City of Port Phillip
Advertised Plan 1 of 40

28-32 ALBERT ROAD, SOUTH MELBOURNE
DRAWING LIST

AMENDMENTS TO ENDORSEMENT PLANS:

Project Title
28-32 ALBERT ROAD
SOUTH MELBOURNE

Drawing Title
GENERAL ARRANGEMENT PLAN
LEVEL 01

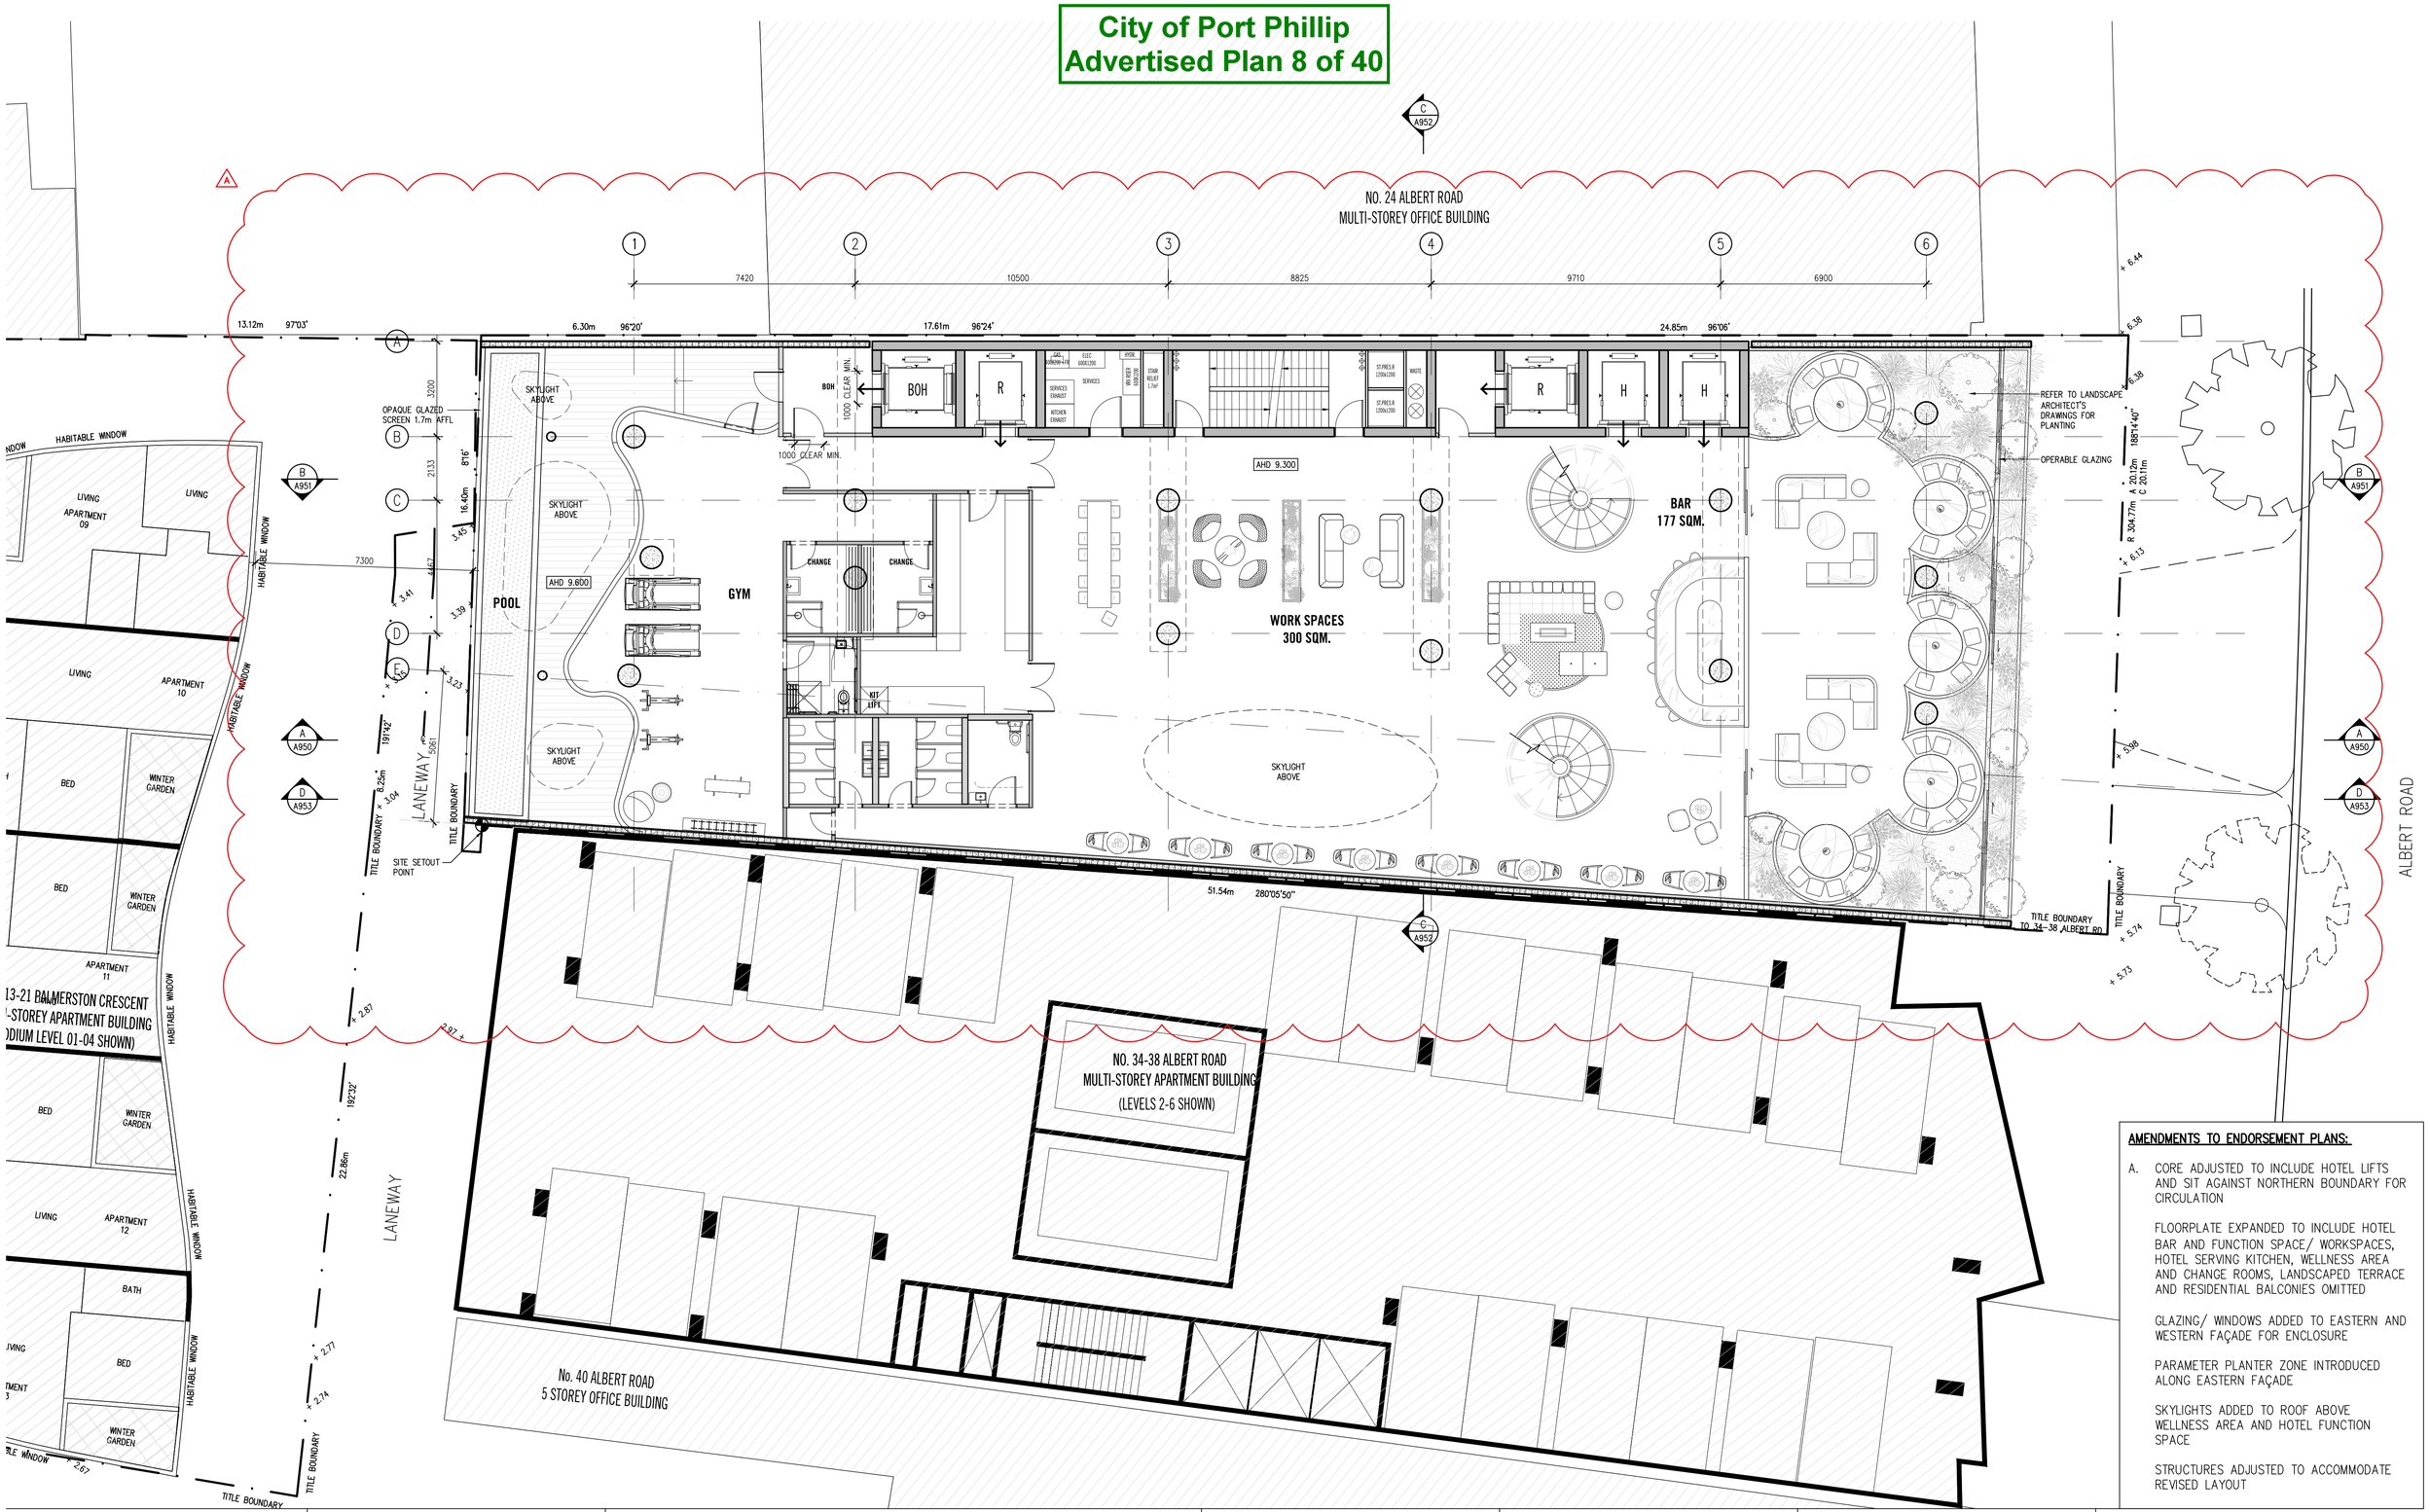
A. CORE ADJUSTED TO INCLUDE HOTEL LIFTS AND SIT AGAINST NORTHERN BOUNDARY FOR CIRCULATION

FLOORPLATE EXPANDED TO INCLUDE HOTEL BAR AND FUNCTION SPACE/ WORKSPACES, HOTEL SERVING KITCHEN, WELLNESS AREA AND CHANGE ROOMS, LANDSCAPED TERRACE AND RESIDENTIAL BALCONIES OMITTED

GLAZING/ WINDOWS ADDED TO EASTERN AND WESTERN FAÇADE FOR ENCLOSURE

PARAMETER PLANTER ZONE INTRODUCED ALONG EASTERN FAÇADE

SKYLIGHTS ADDED TO ROOF ABOVE WELLNESS AREA AND HOTEL FUNCTION SPACE

STRUCTURES ADJUSTED TO ACCOMMODATE REVISED LAYOUT

Drawing Title
GENERAL ARRANGEMENT PLAN
LEVEL 02

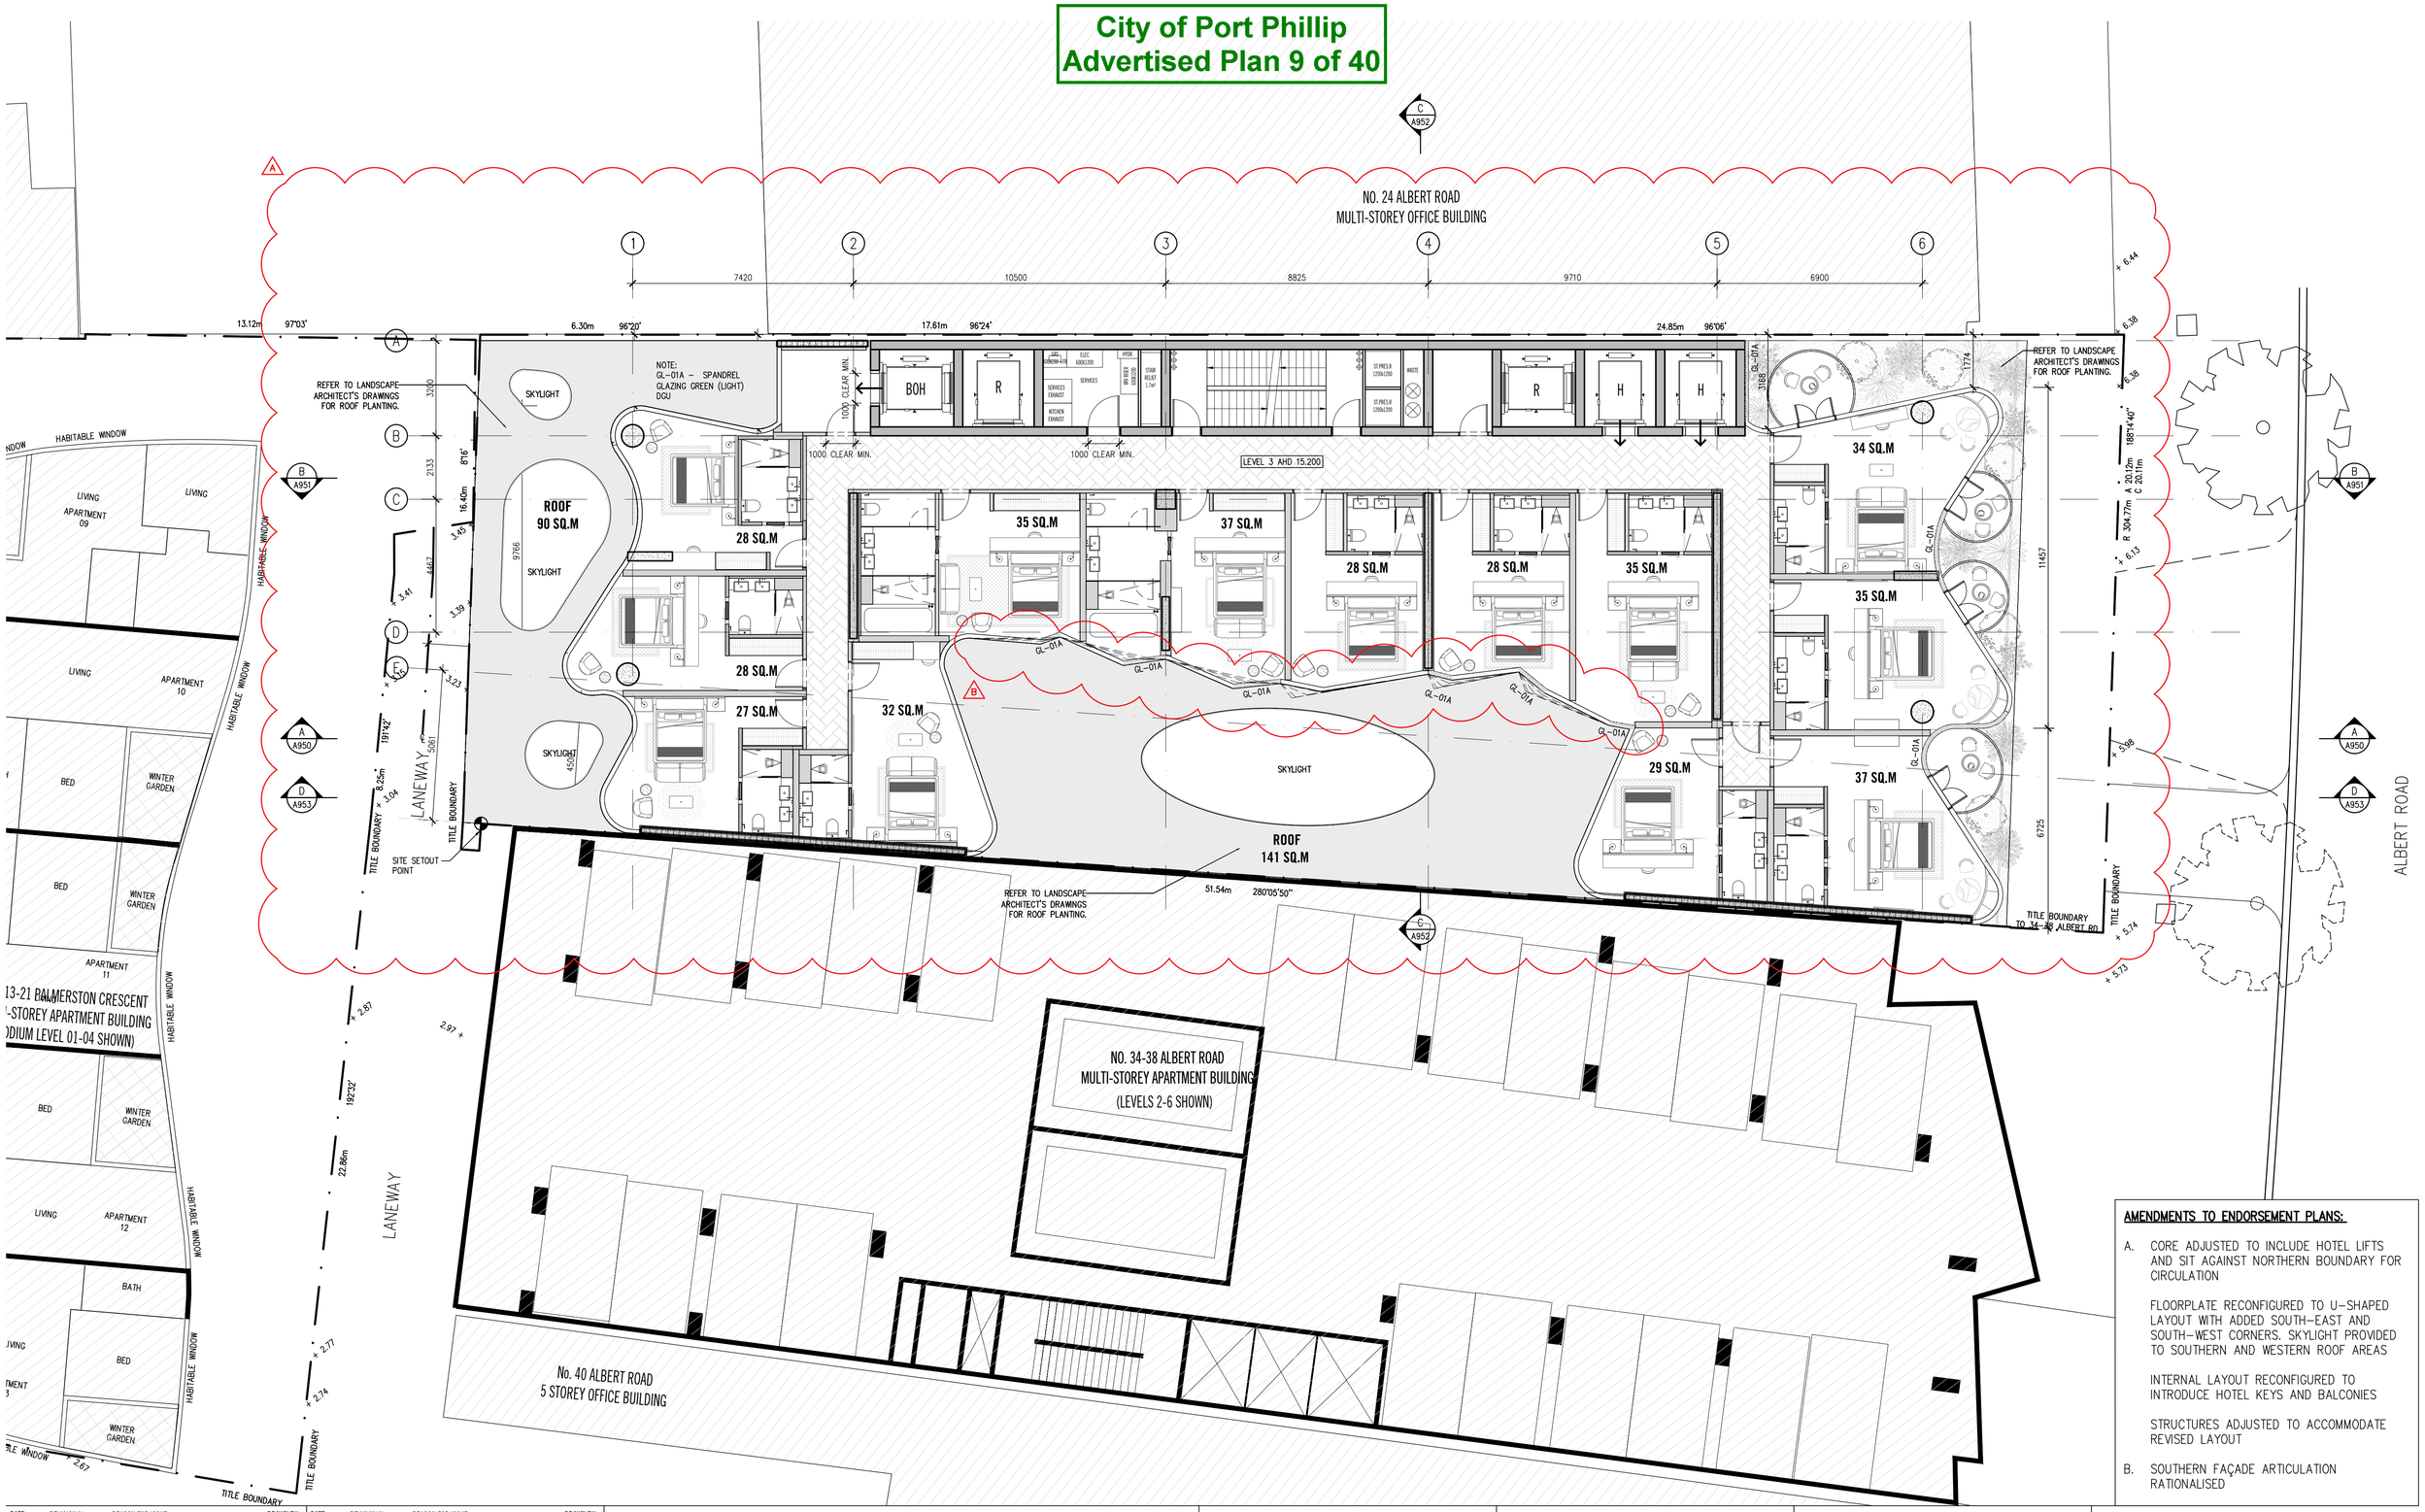
A. CORE ADJUSTED TO INCLUDE HOTEL LIFTS AND SIT AGAINST NORTHERN BOUNDARY FOR CIRCULATION

FLOORPLATE RECONFIGURED TO U–SHAPED LAYOUT WITH ADDED SOUTH–EAST AND SOUTH–WEST CORNERS. SKYLIGHT PROVIDED TO SOUTHERN AND WESTERN ROOF AREAS

STRUCTURES ADJUSTED TO ACCOMMODATE REVISED LAYOUT

Drawing Title
GENERAL ARRANGEMENT PLAN
LEVEL 03 - LEVEL 05

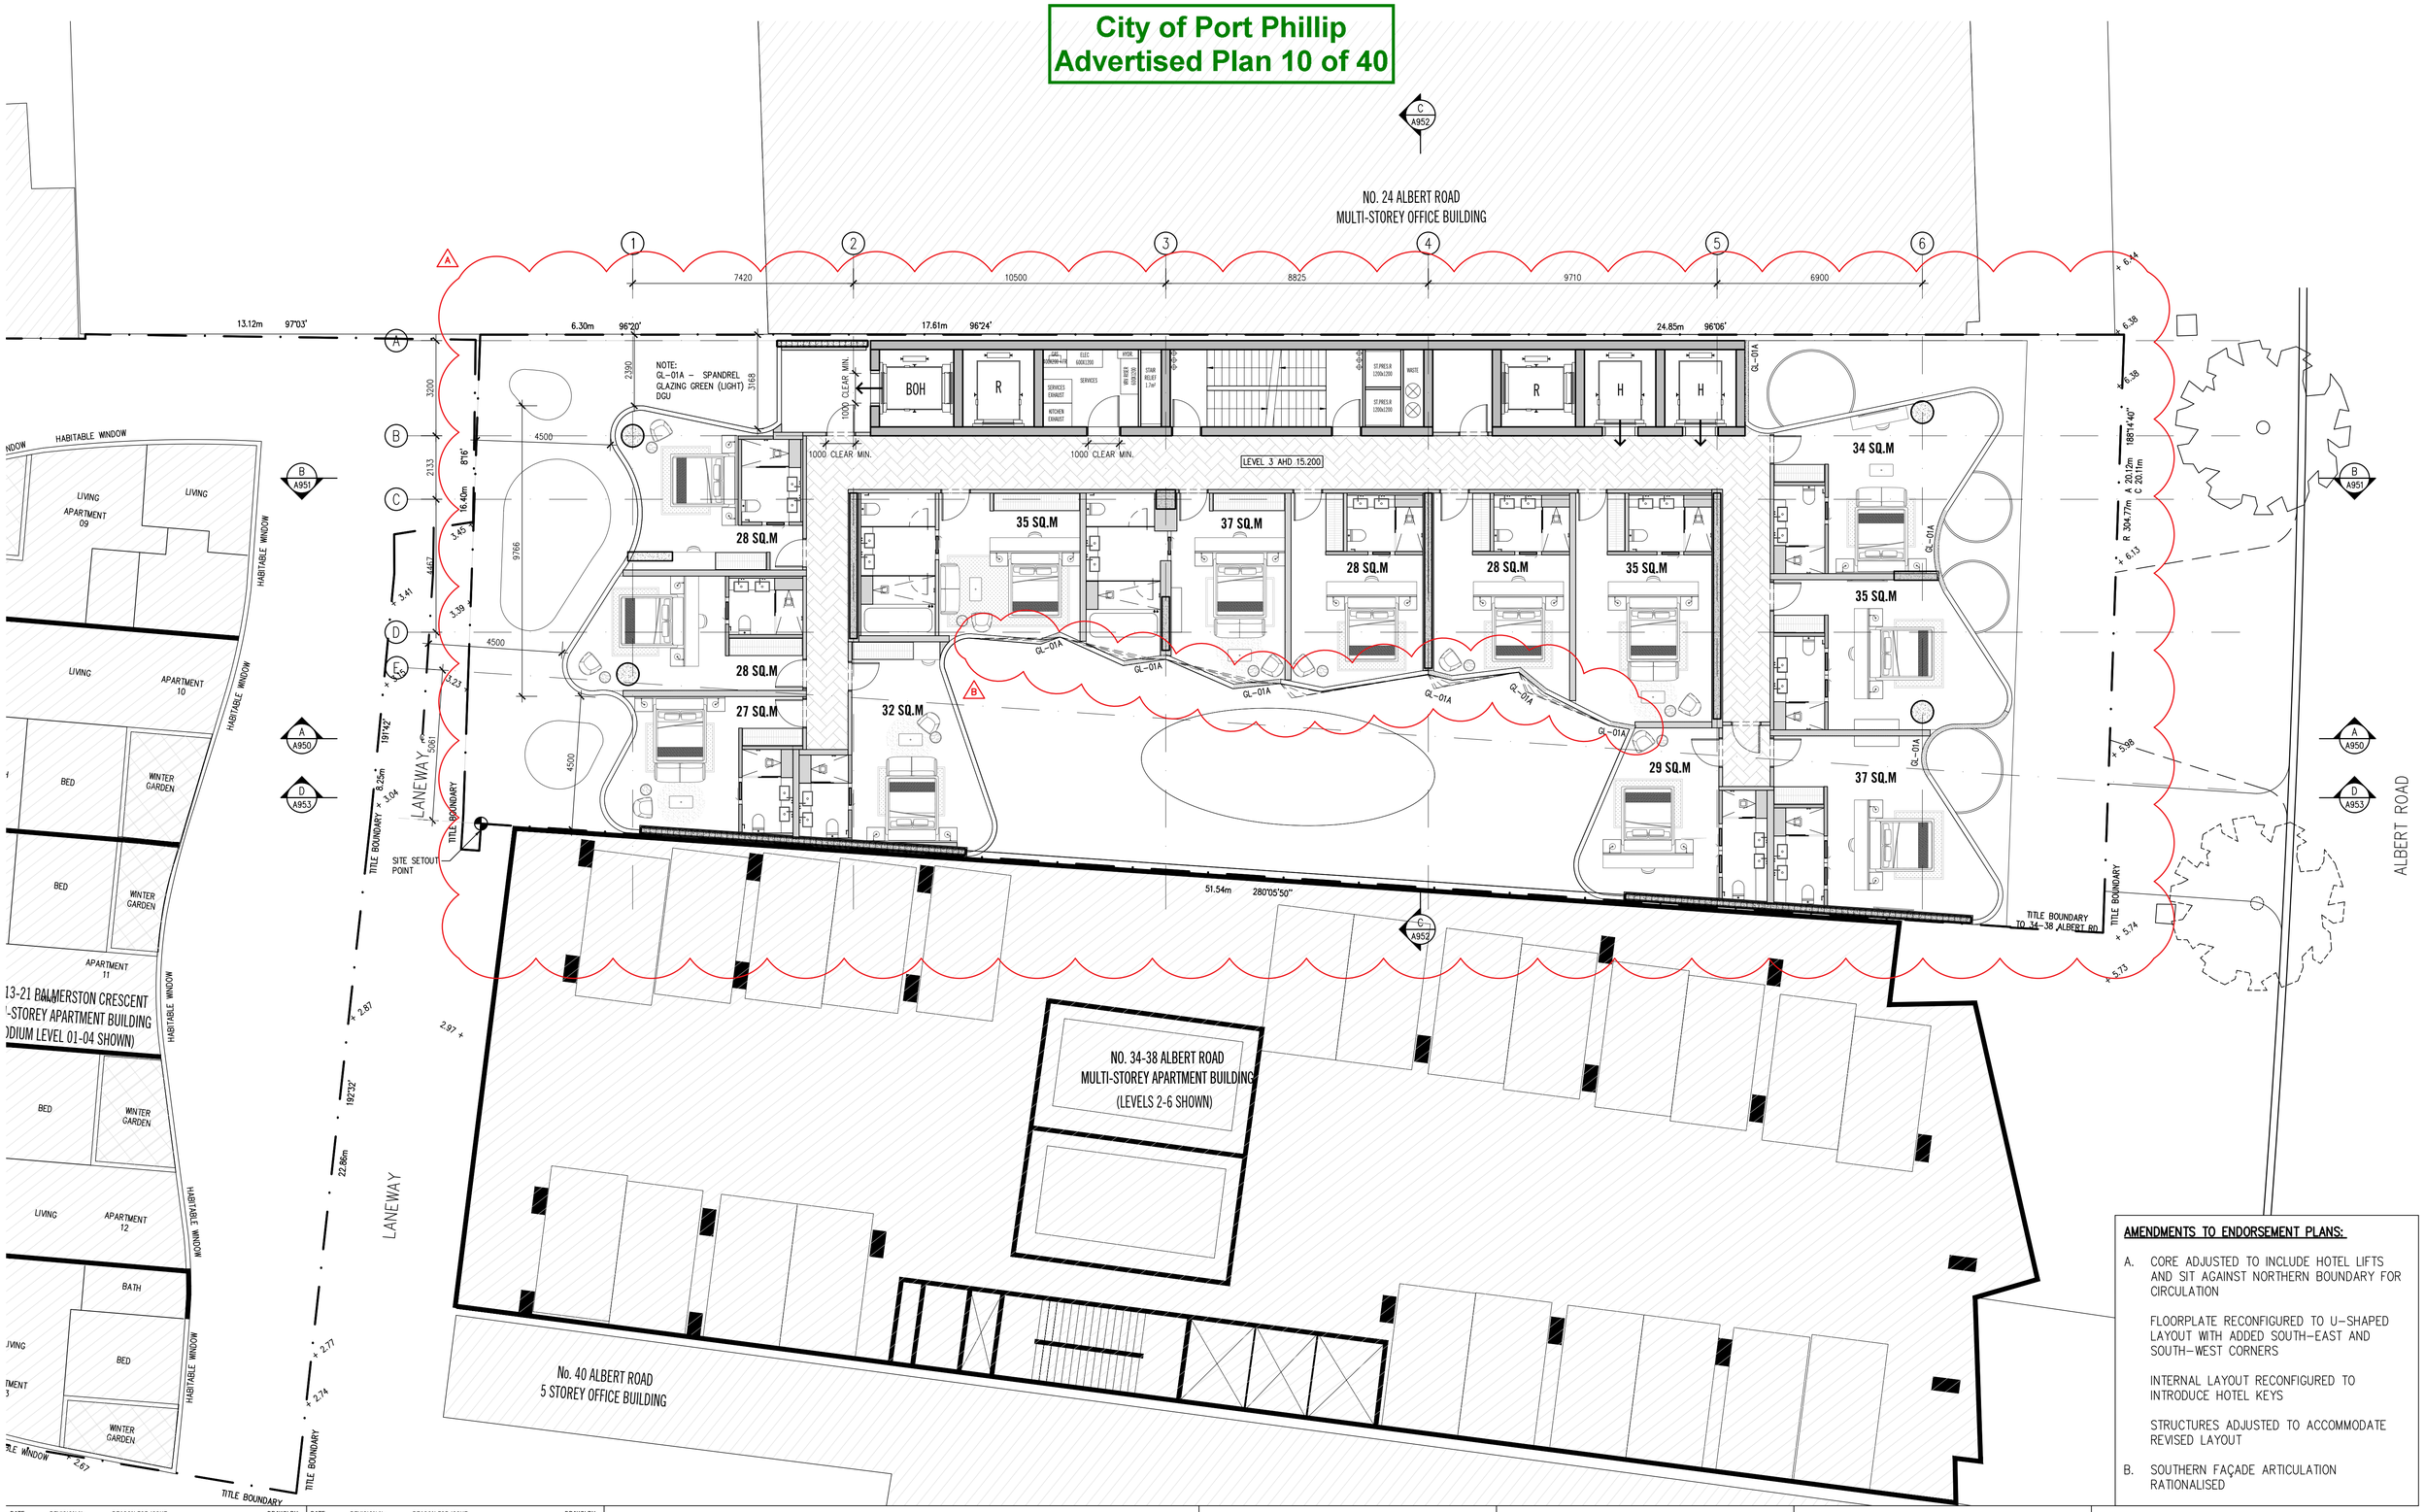
A. CORE ADJUSTED TO INCLUDE HOTEL LIFTS AND SIT AGAINST NORTHERN BOUNDARY FOR CIRCULATION

FLOORPLATE RECONFIGURED TO U-SHAPED LAYOUT WITH ADDED SOUTH-EAST AND SOUTH-WEST CORNERS

STRUCTURES ADJUSTED TO ACCOMMODATE REVISED LAYOUT
